22 April 2016

**Modification Application under Section 96(1a) to SSD_6848 Stage 3B
Redevelopment Of Lismore Base Hospital, Lismore**

Figure 1 Approved vs Proposed Northern Façade (Source: Fitzpatrick + Partners & Fulton Trotter)

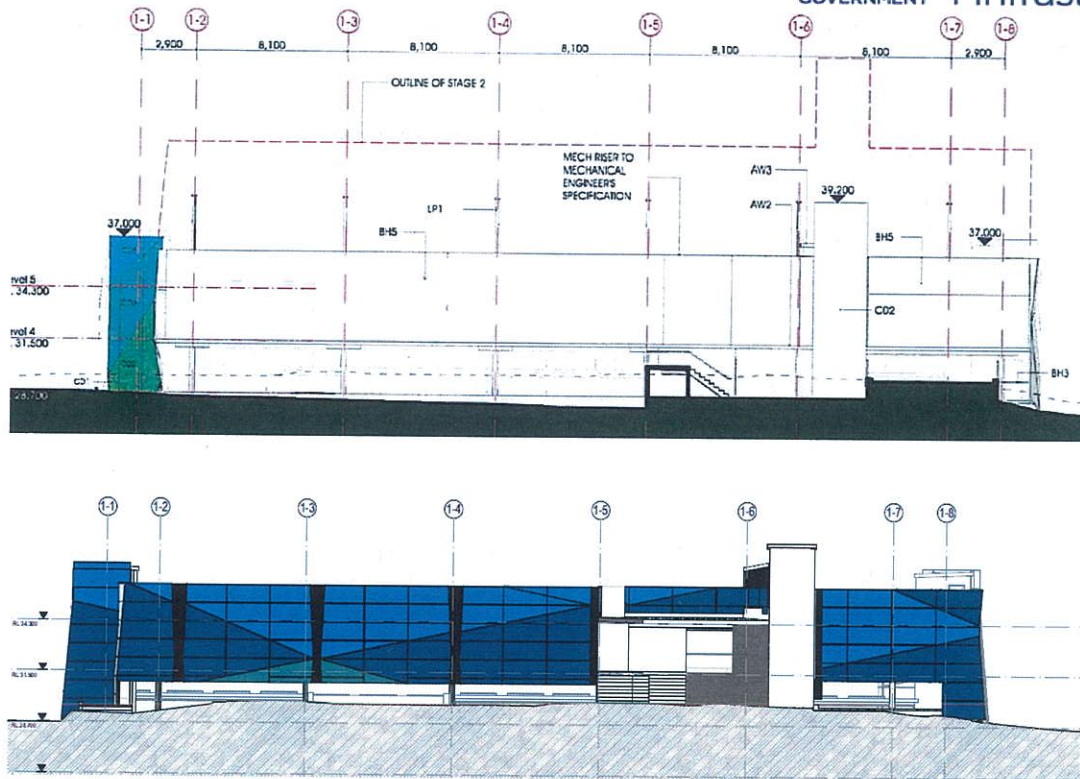
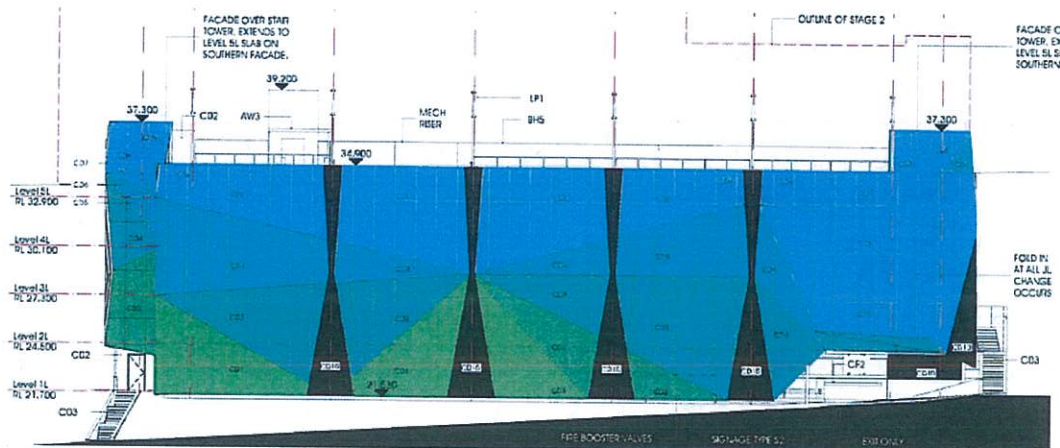
- The material of the northern façade of Stage 1 of the multi-storey carpark is proposed to be amended from a chain wire material to a coloured perforated screen to match the materiality of the other facades;

- A custom orb screen is proposed from the Level 3 slab to the underside of the Level 4 covered walkway roof for waterproofing purposes on the northern elevation (immediately to the east of the lift shaft);

In relation to the change in materials for the northern façade, the inclusion of coloured perforated cladding as opposed to the approved chain wire mesh is considered to be a better visual outcome as it will provide a façade outcome which is consistent with all other facades. It will also provide some visual interest to the northern elevation of Stage 1 from Uralba Street until such time that Stage 2 is constructed.

Figure 2 Approved vs Proposed Southern Façade (Source: Fitzpatrick + Partners & Fulton Trotter)

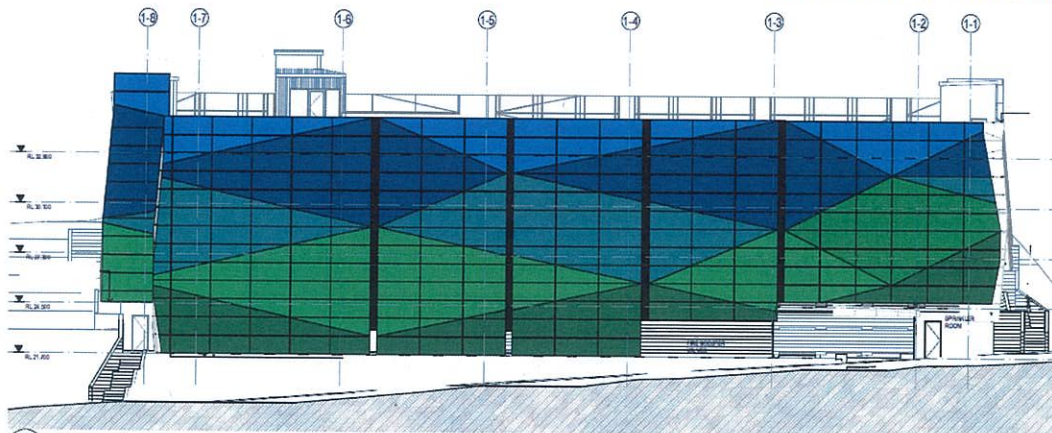
- The façade screen is proposed to be lifted/raised by around 2100-2600mm from the base on the southern and western elevations. The overall height of the façade screen will remain unchanged;

- A small additional section of façade screen has been added immediately to the west of the driveway where it enters Level 3; and
- General changes are proposed to the design of the façades, with the main changes related to the extent of black "guttering" that separates the coloured perforated screen, particularly on the southern elevation.

In relation to the changes to the black "guttering" on the southern elevation, we note that the change is perceptible, but not adverse from a visual perspective for the following reasons:

- The façade design and colours maintain the general design intent including the blue/green colour scheme and folded design. The material also remains as a perforated metal;
- The design of the cladding will comprise multiple "facets" (whilst not identical to those shown on the DA approved elevation, convey a similar random pattern);
- Whilst the black "guttering" is reduced, it is still present and still achieves the objective of breaking up the façade into a series of smaller "vessels" by separating the coloured panels; and
- The approved development included generous mature tree planting within the southern boundary setback zone which will provide screening to the southern façade. The proposal does not seek to modify the approved landscaping scheme.

Figure 3 Approved vs Proposed Eastern Façade (Source: Fitzpatrick + Partners & Fulton Trotter)

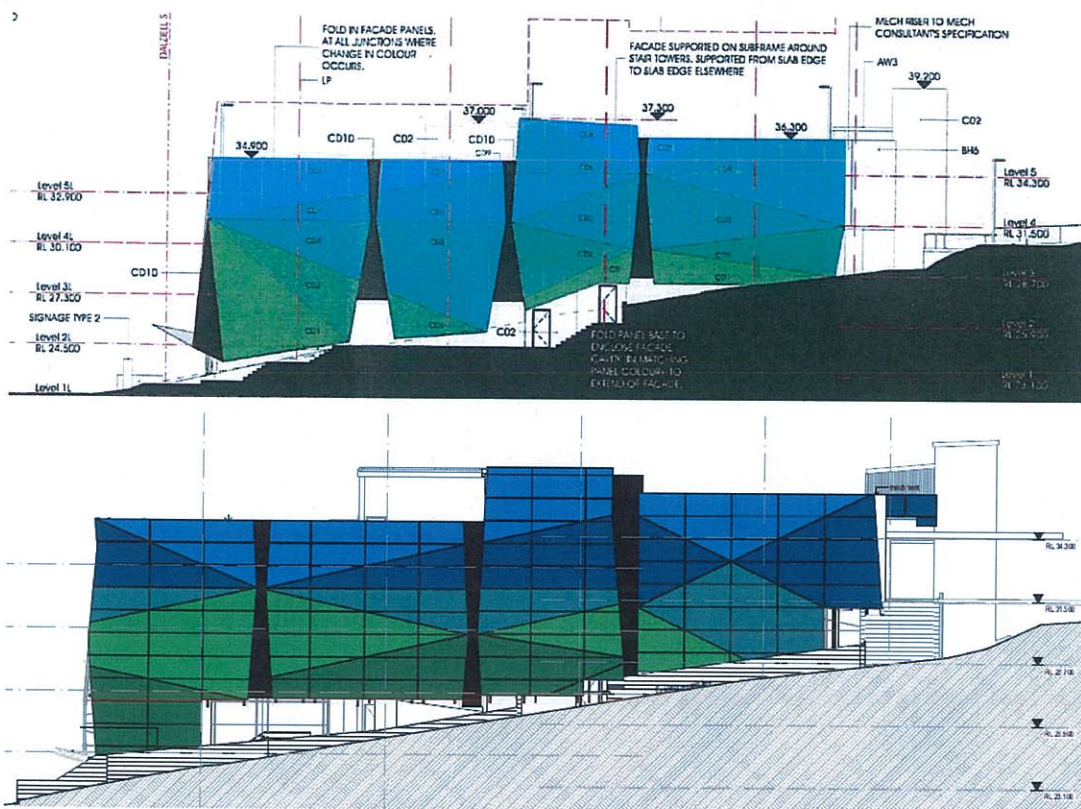
- A small section of façade screen has been deleted from the eastern elevation between Levels 3 & 4, from the lift shaft to the northern façade. There is a covered walkway in this area now, so this section of façade would no longer be seen;

Figure 4 Approved vs Proposed Western Façade (Source: Fitzpatrick + Partners & Fulton Trotter)

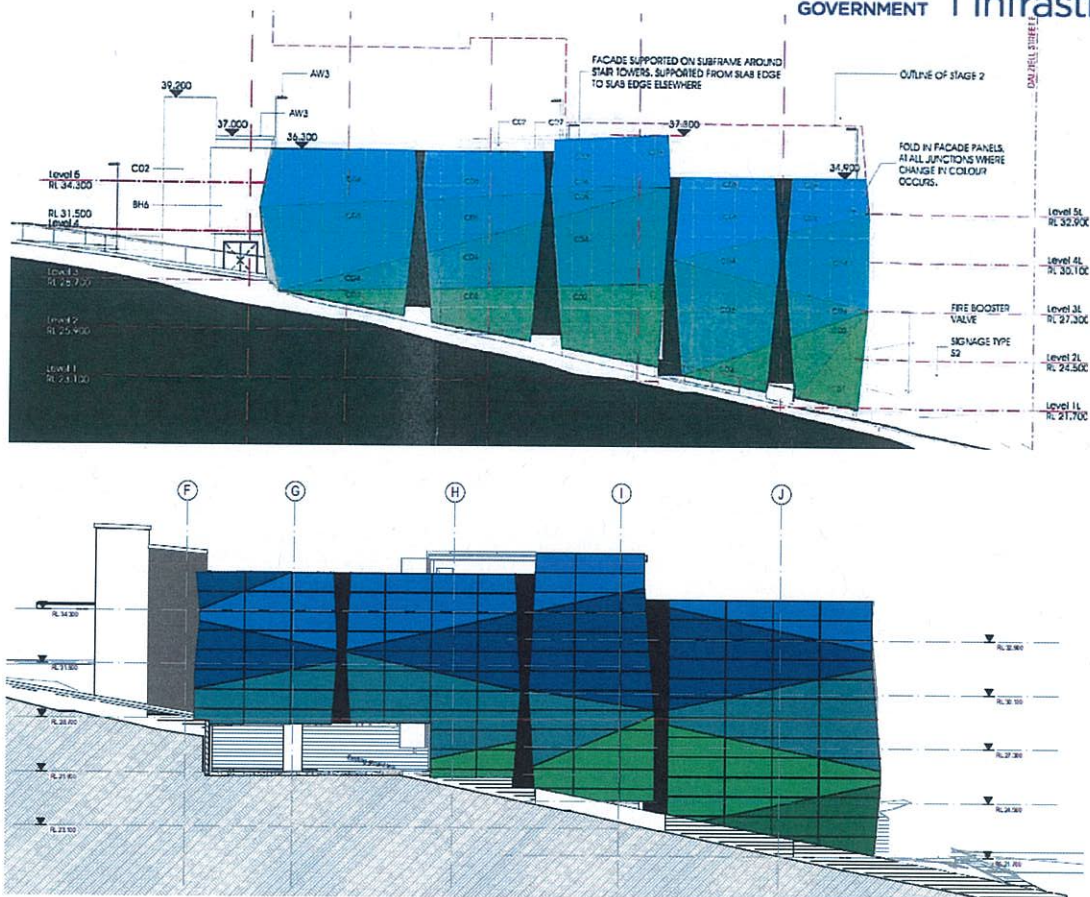
- A vertical colourbond custom orb screen is proposed to the full extent of the western elevation between the lift shaft & the northern façade, from the underside of the lift lobby roof on Level 5 to the point where the lift shaft meets the driveway. It is proposed to delete the section of façade screen to the western elevation to the same area (only previously proposed to Levels 4 & 5);

- The proposed vertical custom orb screen to the full extent of the western elevation between the lift shaft & the northern façade will assist in providing adequate weather protection to the area leading up to the lift shaft whereas the previous finish did not provide this; and
